Access Compliance Report

Public Rights-of-Way

Intersection ID: 44479	Main Street: REDDING_GLEN_AV	Cross Street: DARWICK_ST	Location: SE
ADA ID: A98AC2F33267	Ramp Type: PerpDiag	Initial Pass/Fail: Fail	Overall Compliance: No
		Severity Score: 8.75

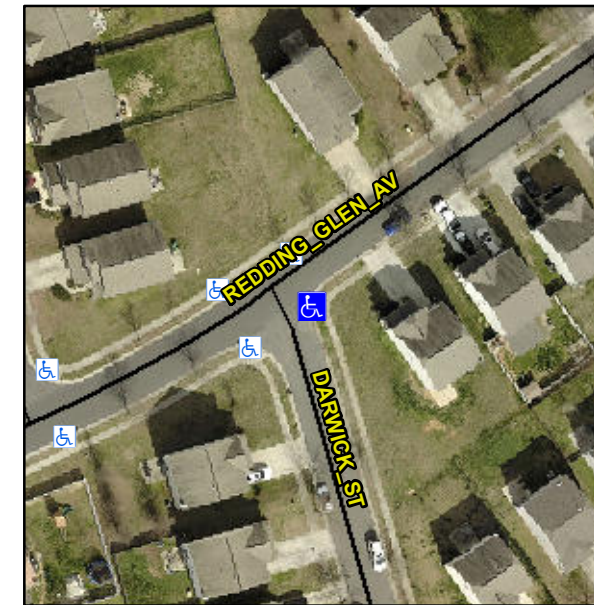
Not Found, R304.5.1

Compliance	Description	Data	Compliance	Description	Data
N/A	Ramp Length (in)	48.0	Yes	Ramp Slope (%)	5.9
No	Ramp Width (in)	46.0	Yes	Ramp XSlope (%)	0.1
N/A	Flare Type LT	N/A	N/A	Flare Type RT	N/A
N/A	Flare Slope LT (%)	N/A	N/A	Flare Slope RT (%)	N/A
N/A	Flare Traversable LT?	N/A	N/A	Flare Traversable RT?	N/A
N/A	Landing Length (in)	N/A	N/A	DWS Provided?	N/A
N/A	Landing Width (in)	N/A	N/A	DWS Contrast?	N/A
N/A	Landing Slope (%)	N/A	N/A	DWS Length (in)	N/A
N/A	Landing X Slope (%)	N/A	N/A	DWS Full Width?	N/A
N/A	Landing Curb? (Y/N)	N/A	N/A	DWS Offset (in)	N/A
N/A	Shared Landing?	N/A			
N/A	Gutter Ponding?	N/A	N/A	Gutter Slope (%)	N/A
N/A	Gutter Lip Ht (in)	N/A	N/A	Gutter X Slope (%)	N/A
N/A	Painted X Walk1?	No	N/A	Painted X Walk2?	No
	X Walk 1 Direction	To N		X Walk 2 Direction	To W
N/A	X Walk 1 Width (in)	N/A	N/A	X Walk 2 Width (in)	N/A
	X Walk 1 Slope (%)	3.5		X Walk 2 Slope (%)	1.7
	X Walk 1 X Slope (%)	0.5		X Walk 2 X Slope (%)	1.6

Remove & Replace Curb Ramp With Two New Directional Ramps or Equivalent.
